ADDENDUM NO. 1

**Water & Wastewater Improvements
Graham Cave State Park
Danville, Missouri
Project No. X2321-01**

Bidders are hereby informed that the construction Plans and/or Specifications are modified as follows:

D-104

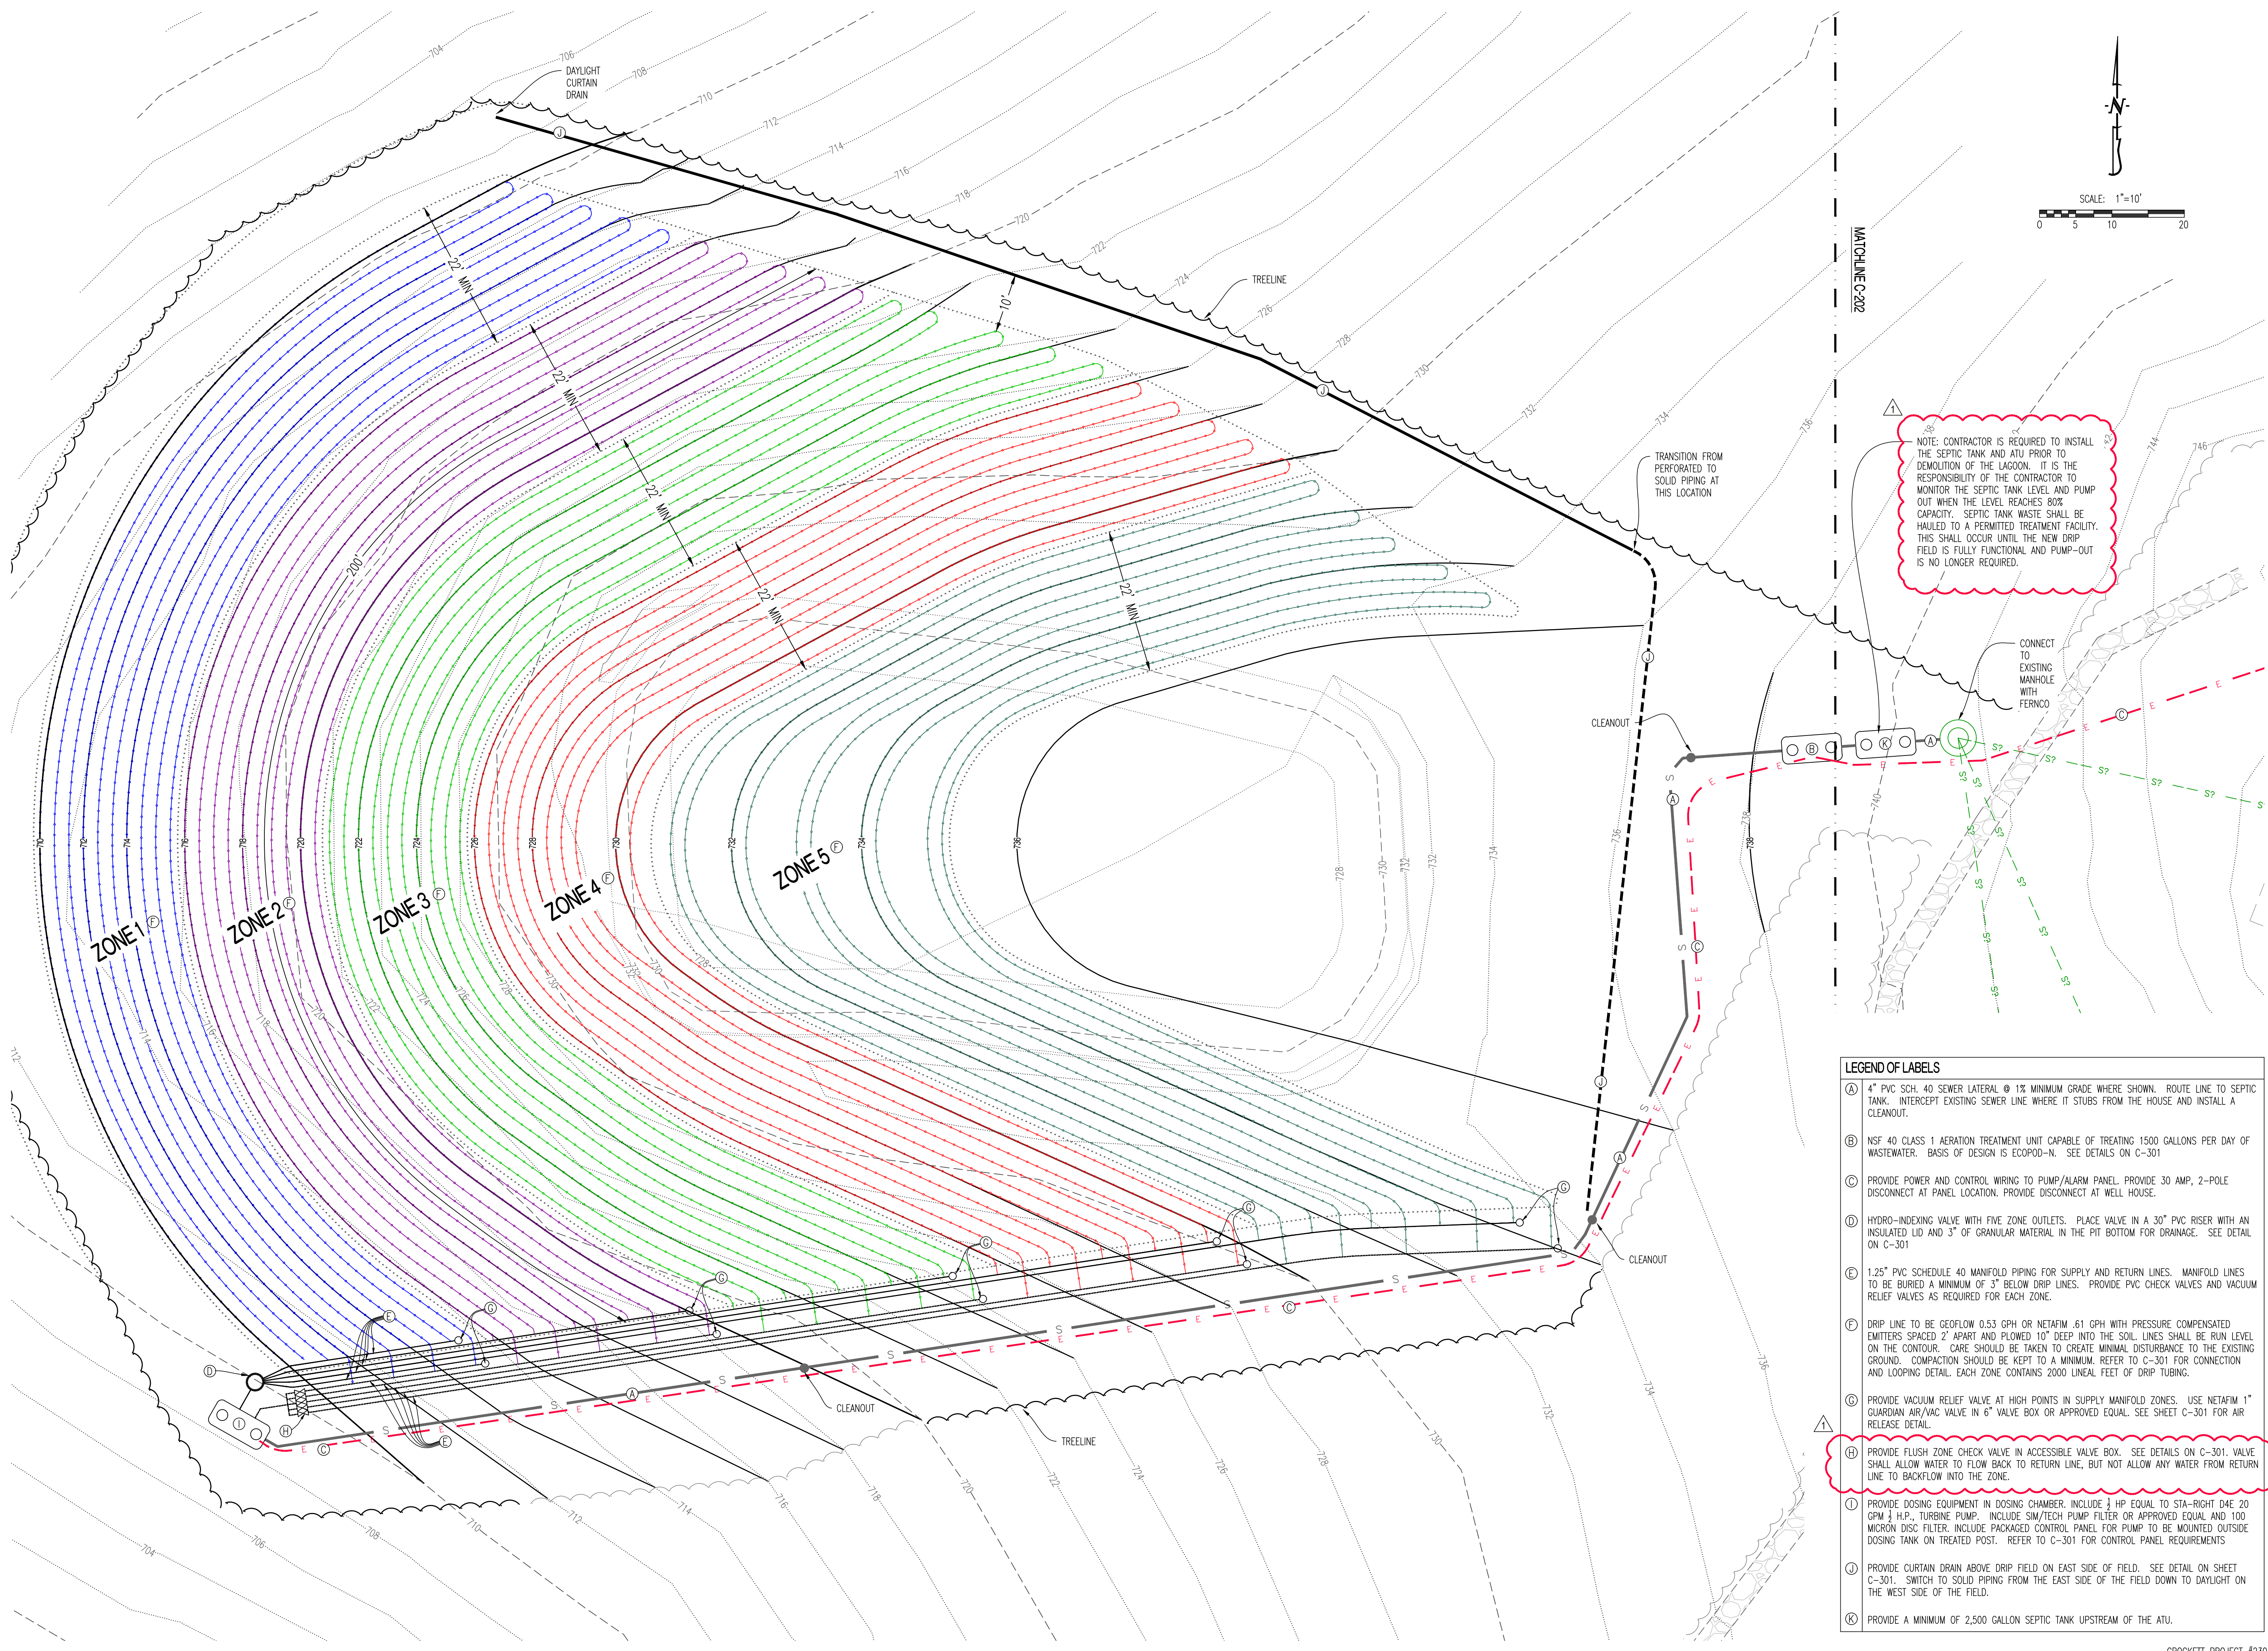
4. Sheet D-104
 - a. Modify electrical wiring note to show coordination required with electric company and removal length modified.
 - b. Key Note D modified to show electrical wiring requirements and coordination required with park staff for fuel tank relocation.

- c. Pictorial exhibit added to show electrical connections to tankage.
 - d. Sheet title updated.
 - e. See attached revised drawing.
5. Sheet C-201
 - a. Note added to show septic tank waste monitoring and pump-out requirements during construction.

- (D) CONTRACTOR TO RELOCATE EXISTING FUEL TANKS AND POUR PAD AT NEW LOCATION. ONCE TANKS HAVE BEEN REMOVED, SAWCUT AND REMOVE EXISTING CONCRETE PAD. SALVAGE EXISTING ELECTRICAL CONDUITS BETWEEN TANKS FOR RE-INSTALLATION, OR PROVIDE NEW CONDUITS MATCHING THE EXISTING CONDITION. INSTALL NEW ELECTRICAL WIRING FROM WELL HOUSE TO NEW FUEL TANK LOCATION. REMOVE EXISTING WIRING BACK TO PANEL IN EXISTING SHED. PARK STAFF WILL COORDINATE WITH CONTRACTOR TO HAVE FUEL TANKS AS EMPTY AS POSSIBLE PRIOR TO MOVE TO NEW PAD LOCATION. SEE PICTURE BELOW.

REMOVE AND DISCONNECT WIRING FROM SEWER METER BACK TO POLE. COORDINATE WITH ELECTRIC COMPANY

C-203

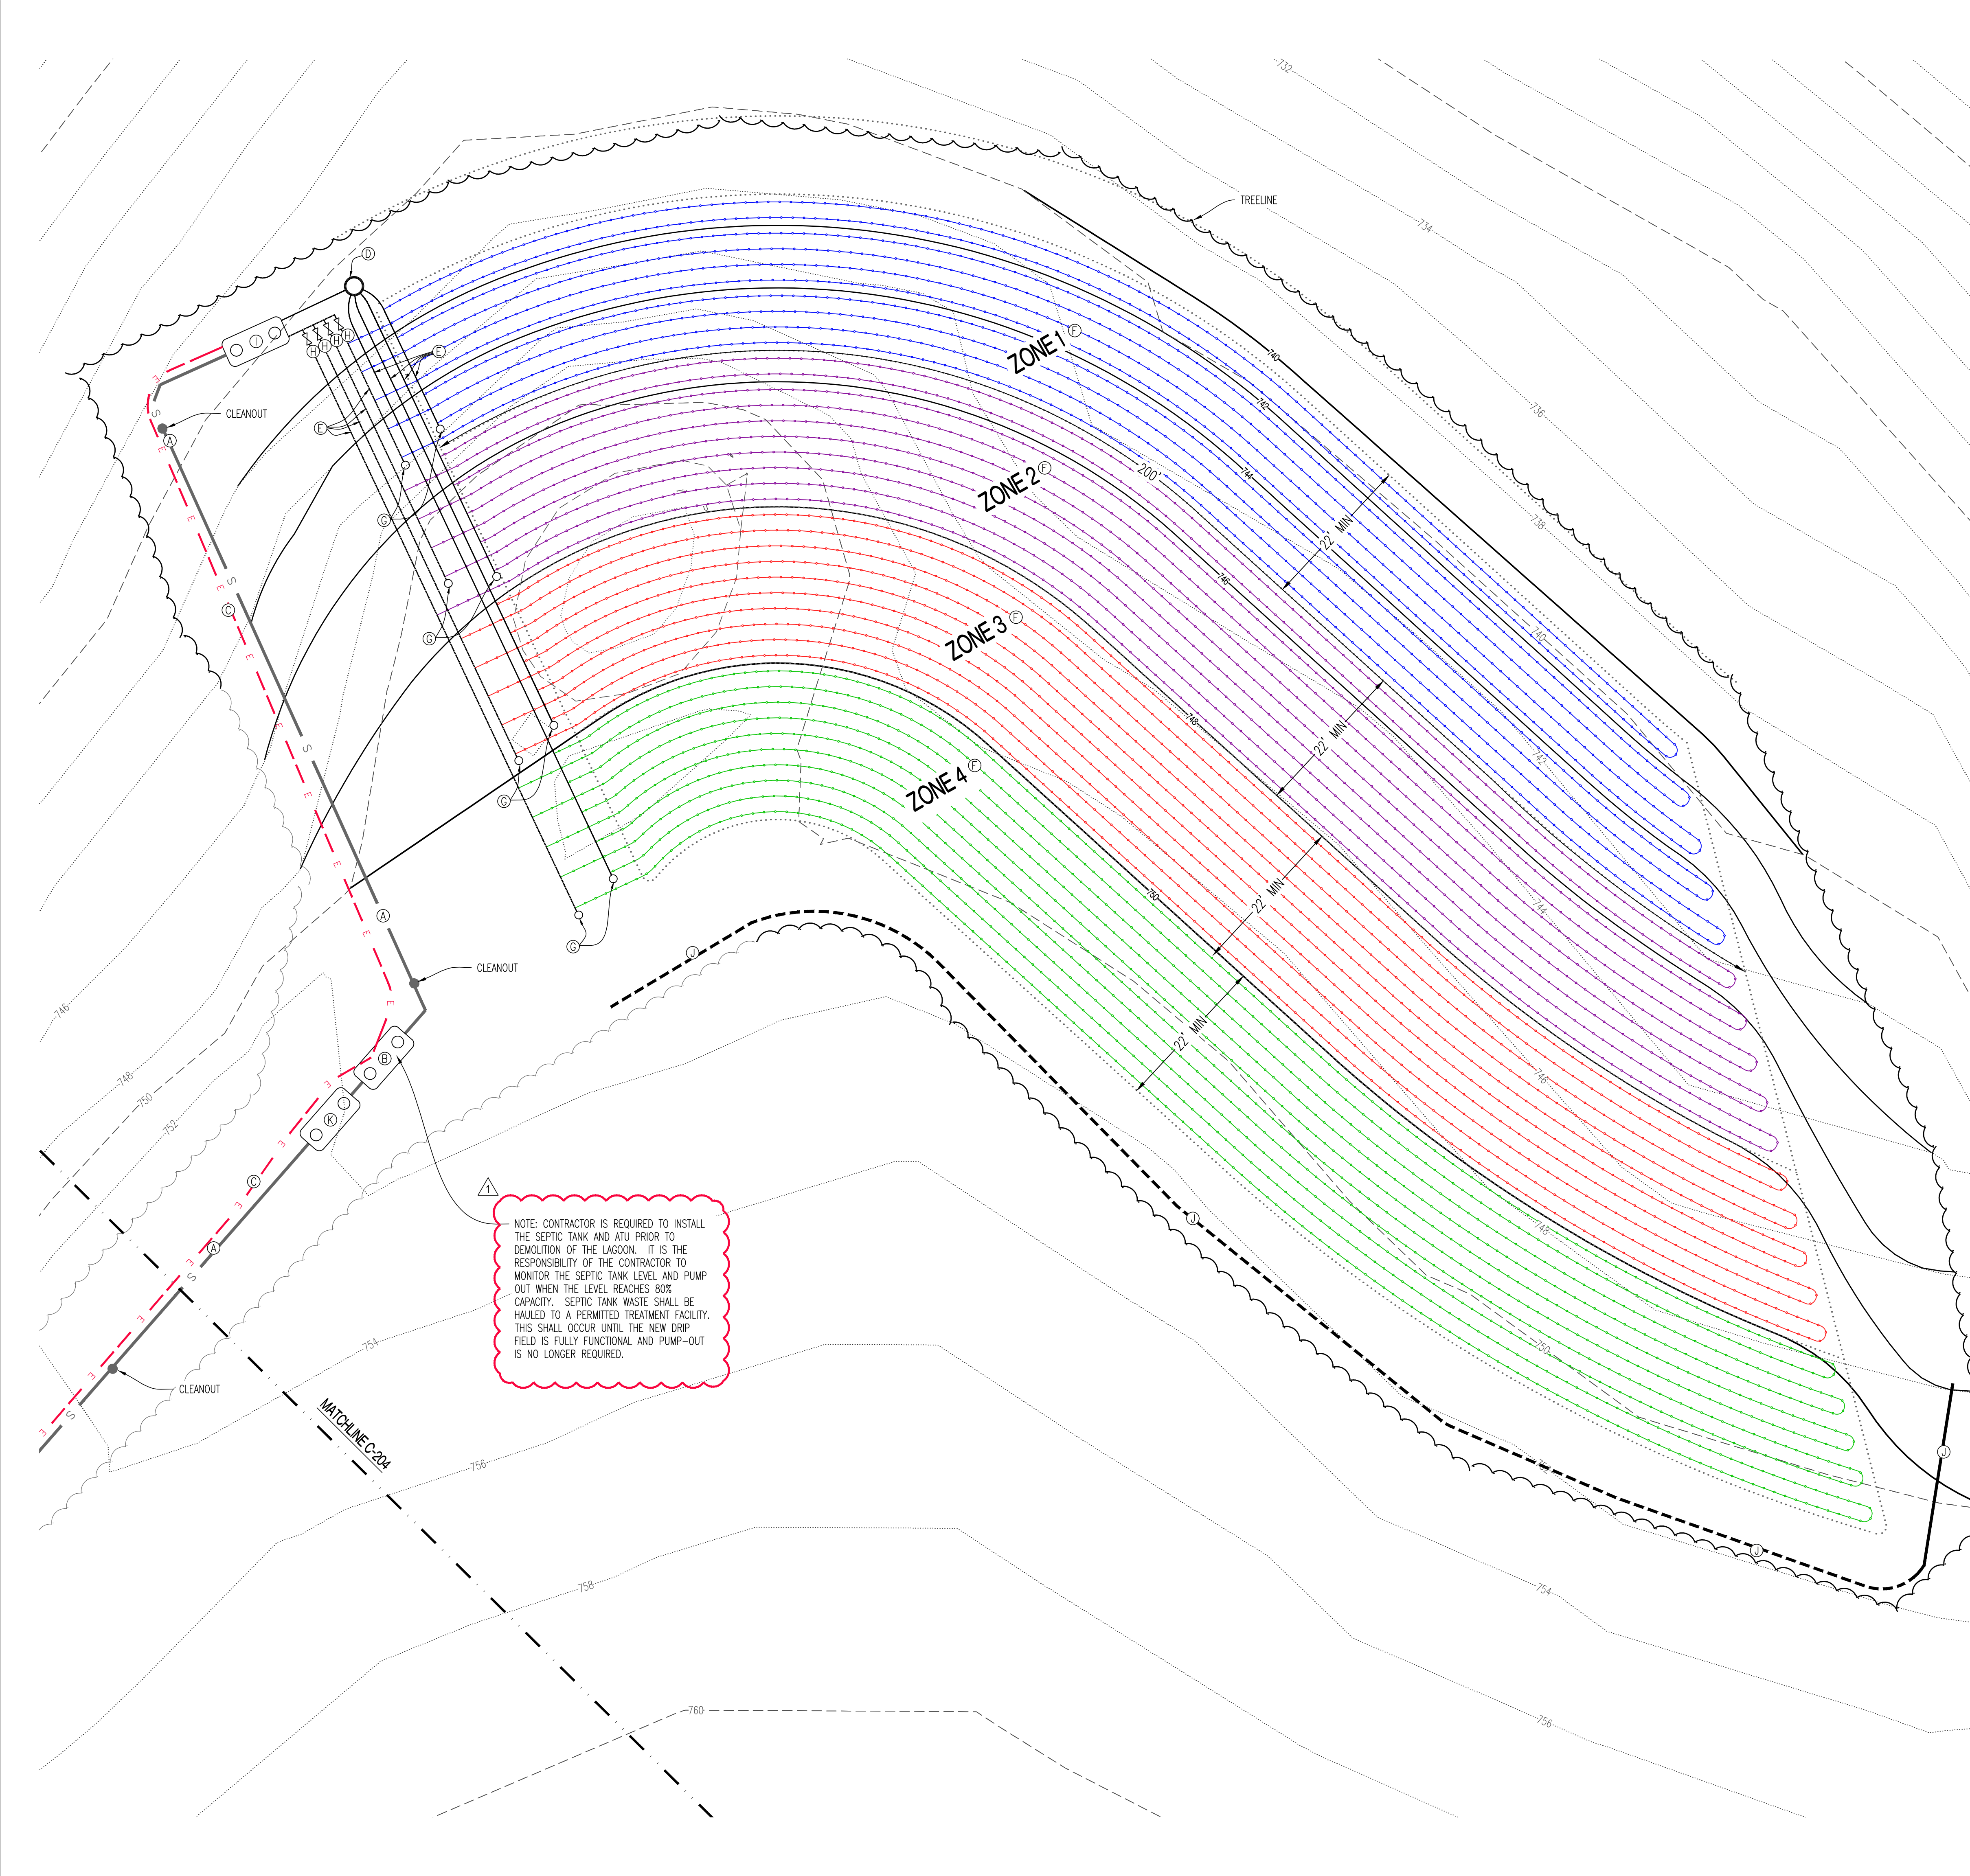
- b. Key note H modified to clarify requirements for zone check valve.
 - c. See attached revised drawing.
6. Sheet C-203
 - a. Note added to show septic tank waste monitoring and pump-out requirements during construction.

- b. Key note H modified to clarify requirements for zone check valve.
 - c. See attached revised drawing.

NOTE: CONTRACTOR IS REQUIRED TO INSTALL THE SEPTIC TANK AND ATU PRIOR TO DEMOLITION OF THE LAGOON. IT IS THE RESPONSIBILITY OF THE CONTRACTOR TO MONITOR THE SEPTIC TANK LEVEL AND PUMP OUT WHEN THE LEVEL REACHES 80% CAPACITY. SEPTIC TANK WASTE SHALL BE HAULED TO A PERMITTED TREATMENT FACILITY. THIS SHALL OCCUR UNTIL THE NEW DRIP FIELD IS FULLY FUNCTIONAL AND PUMP-OUT IS NO LONGER REQUIRED.

- (H) PROVIDE FLUSH ZONE CHECK VALVE IN ACCESSIBLE VALVE BOX. SEE DETAILS ON C-301. VALVE SHALL ALLOW WATER TO FLOW BACK TO RETURN LINE, BUT NOT ALLOW ANY WATER FROM RETURN LINE TO BACKFLOW INTO THE ZONE.
